Access Compliance Report Public Rights-of-Way (Curb Ramps)

Main Street: IRVINE_BLVD		Cross Street: CHARLOMA_DR		Location:	NW
ADA ID: RPAT211027111000	Ramp Type: Type 3 - Combination 1	Initial Pass/Fail: Pass	Overall Compliance: No	Severity Score:	0
Codes/Mitigation Info/Possible Solution			Field Measurements/Component Compliance

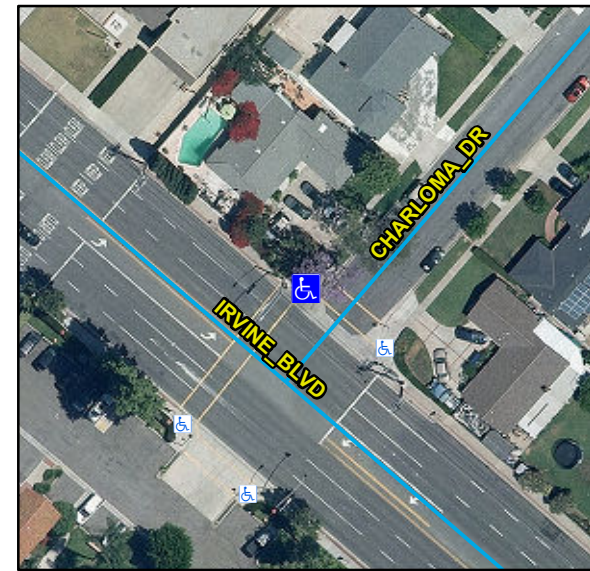
Remove & Replace Curb Slope.
